**DOCKET ITEM #8**  
**Subdivision #2024-00003**  
**635 Upland Place**

<b>Application</b>	<b>General Data</b>	
<b>Request:</b> Public hearing and consideration of a request for a subdivision with variations to re-subdivide an existing lot into two lots.	<b>Planning Commission Hearing:</b>	June 4, 2024
	<b>Approved Plat must be Recorded By:</b>	December 4, 2025
<b>Address:</b> 635 Upland Place	<b>Zone:</b>	R-5/Residential
<b>Applicant:</b> Windmill Hill LLC represented by M. Catharine Puskar, attorney	<b>Small Area Plan:</b>	Taylor Run/Duke Street

**Staff Recommendation:** APPROVAL subject to compliance with all applicable codes, ordinances, and recommended conditions found in Section III of this report.

# EXHIBIT B

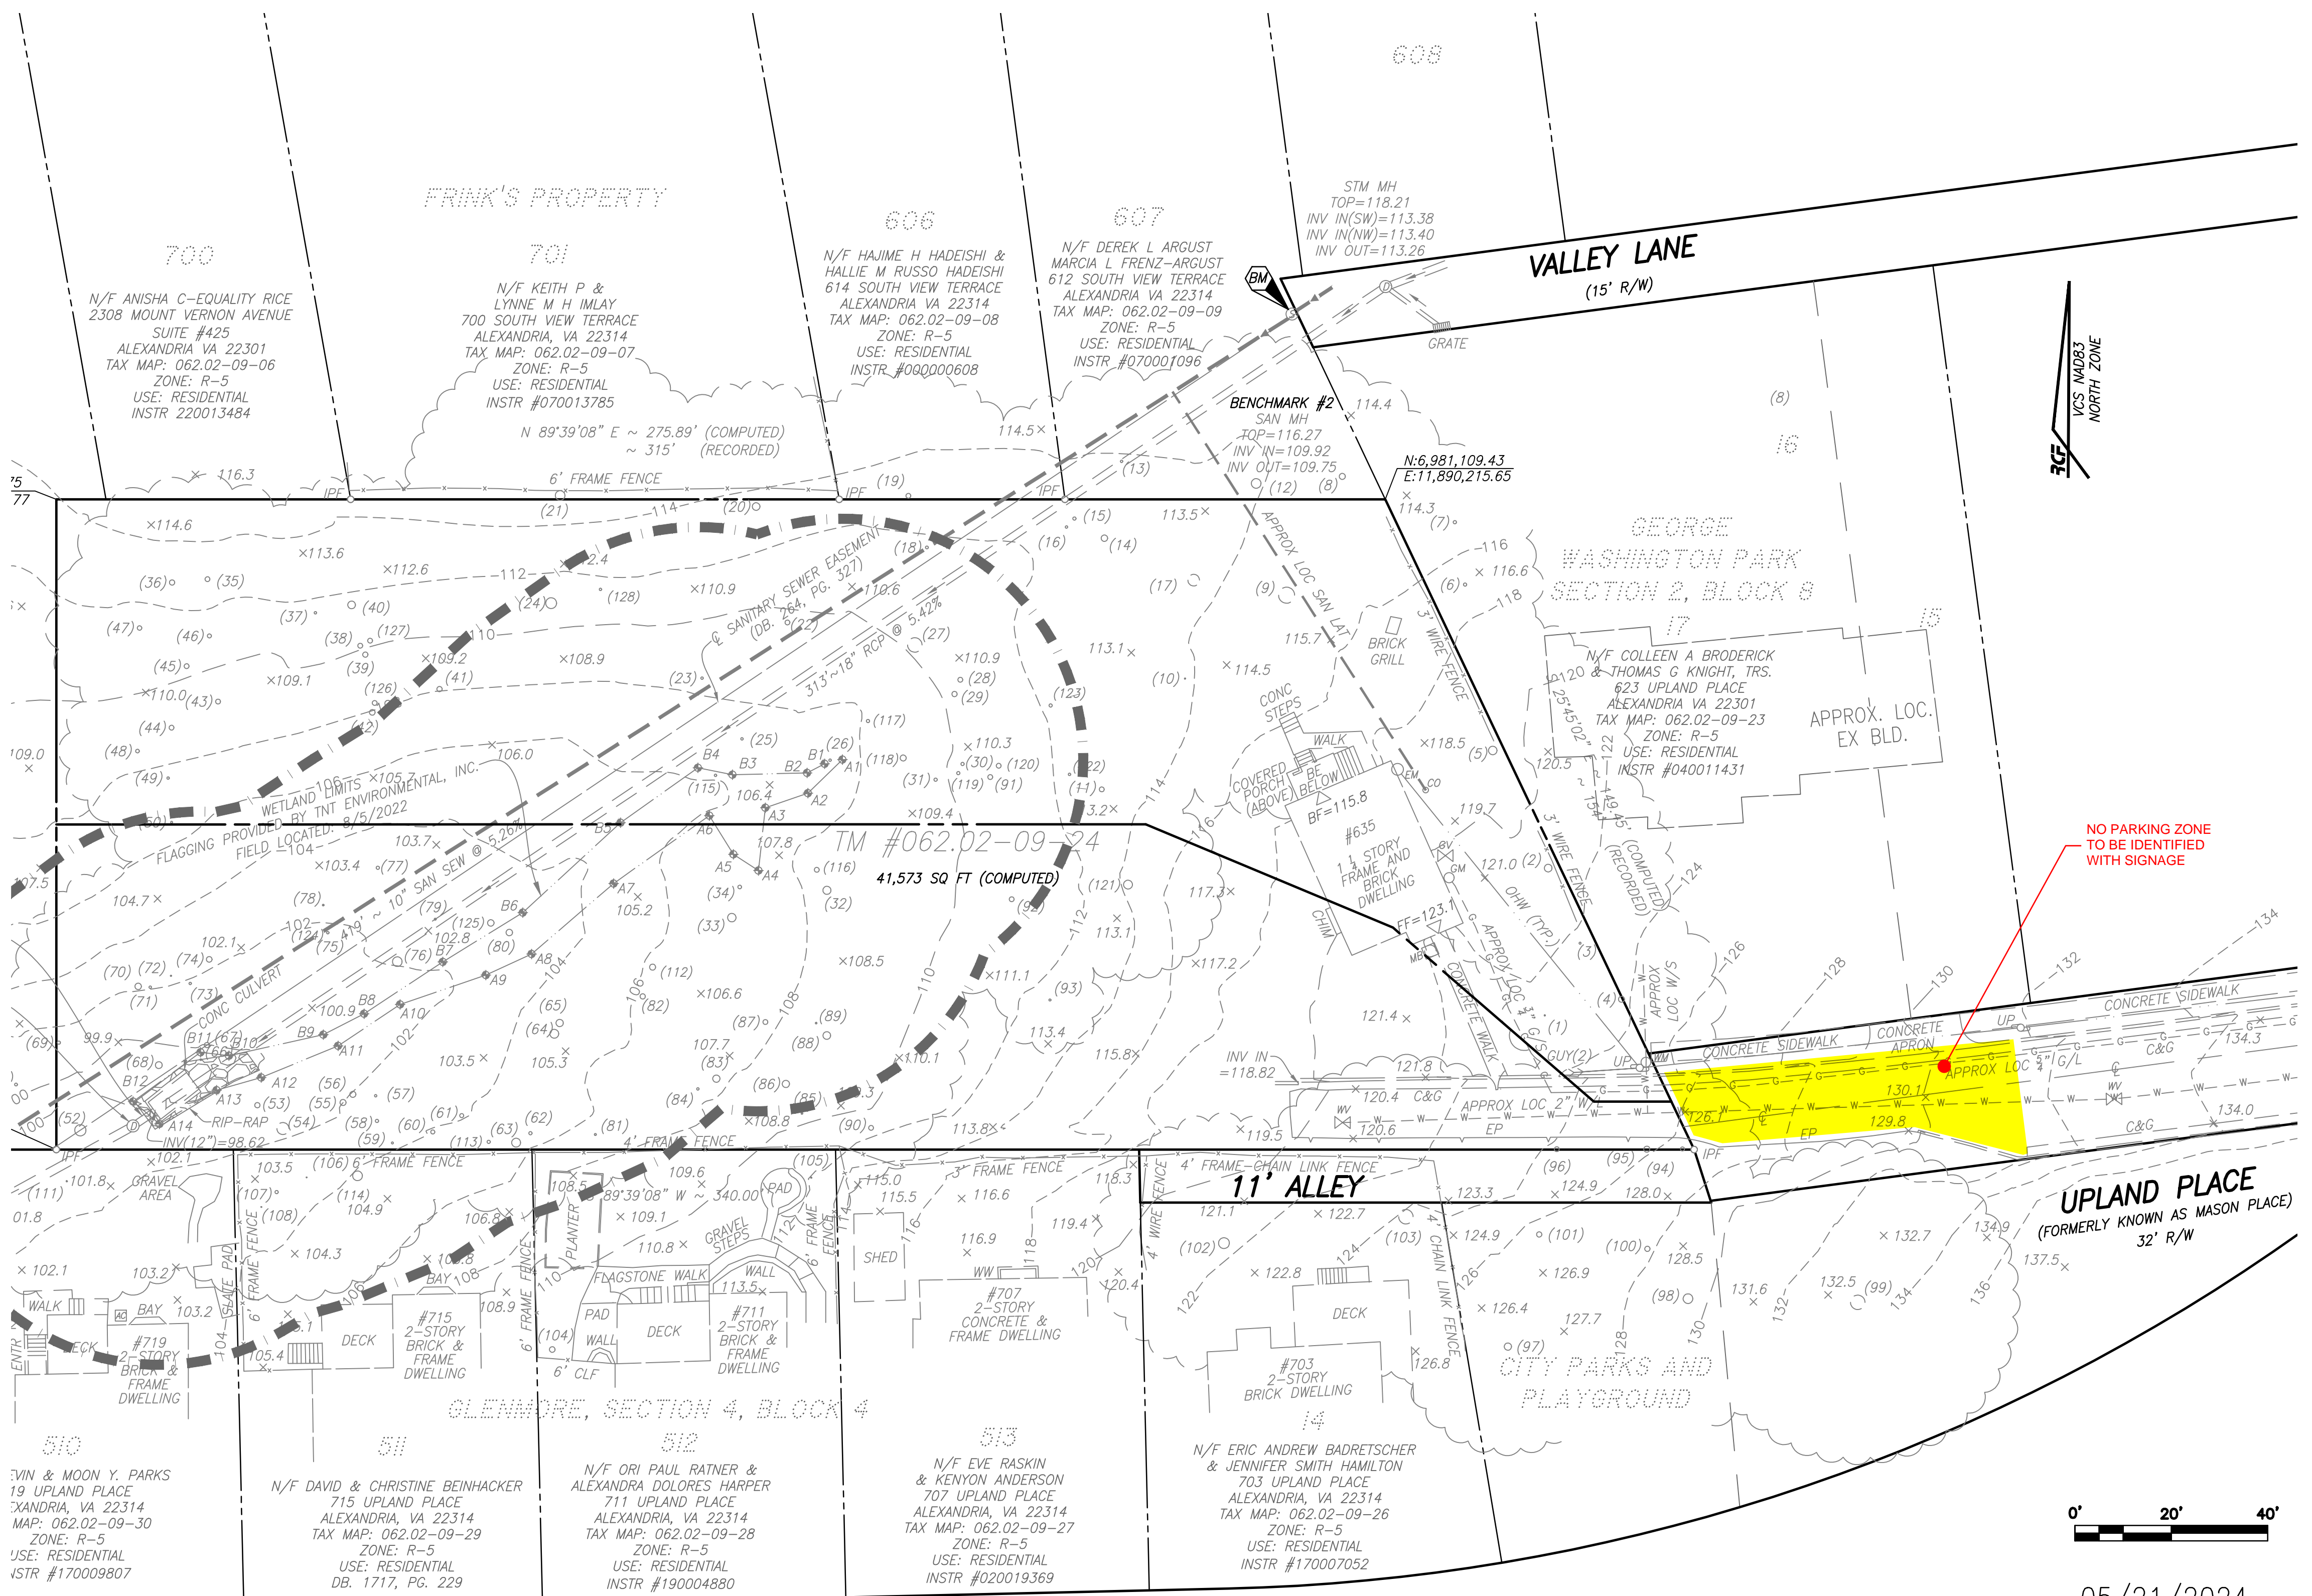
NO PARKING ZONE  
TO BE IDENTIFIED  
WITH SIGNAGE

The application appears to ask (in the accompanying Conceptual Layout) that the city establish a no-parking zone on the stub end of Upland Place, apparently to protect the applicant’s street frontage and access. It is interesting that this requested no-parking zone extends along nearly the entire street frontage of 623 Upland Place, the adjoining parcel on Upland. The applicant seeks to force its neighbors to give up the street parking in front of their own house so that the applicant can build two houses on its own land. Unsurprisingly, it offers no account of what the neighbors think of this proposal, or what will happen whenever they—or the residents of the proposed houses—host a party.

To accommodate the subdivision, if approved, the plans show that the city will be removing parking from the current street for the creation of these new lots. Removing parking from the public right-of-way to facilitate the development cannot be seen as a benefit to the surrounding neighborhood and the existing homes.

R-1 The applicant shall install “no parking” signs on both sides of Upland Place in the area shown on Exhibit C submitted May 21, 2024 to the satisfaction of the Chief Fire Marshall. (Fire)

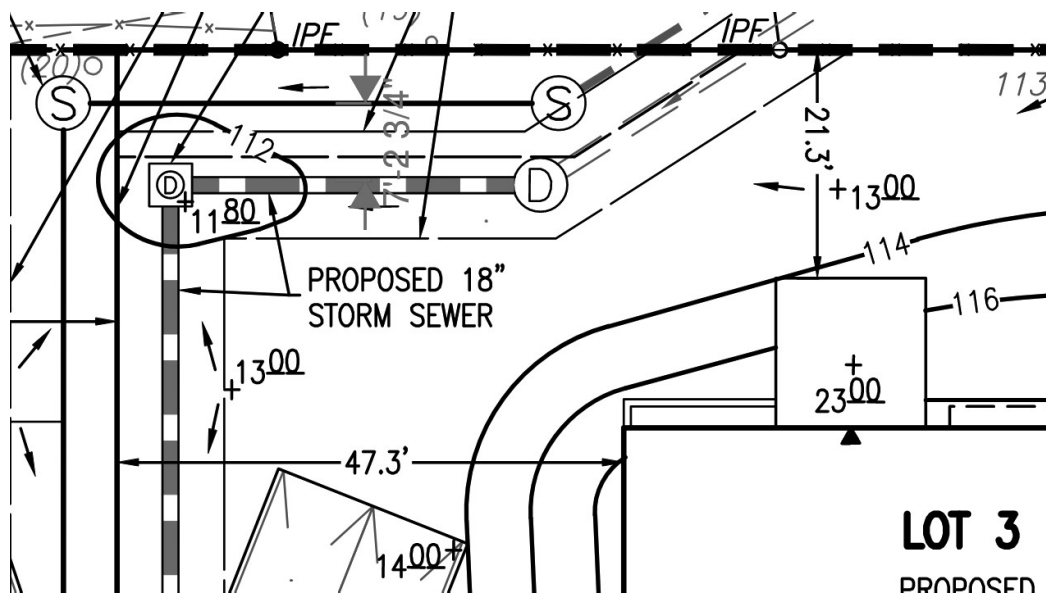
22. On sheet 4, there is only one “No Parking” sign which is not enough to prevent cars from parking along the cul-de-sac. Provide more signage to enforce the restriction. (Traffic Engineering)
23. Provide a completed curb with a crosswalk at the end of the spur back across to the main sidewalk on Upland Place like shown below. (Transportation Planning)
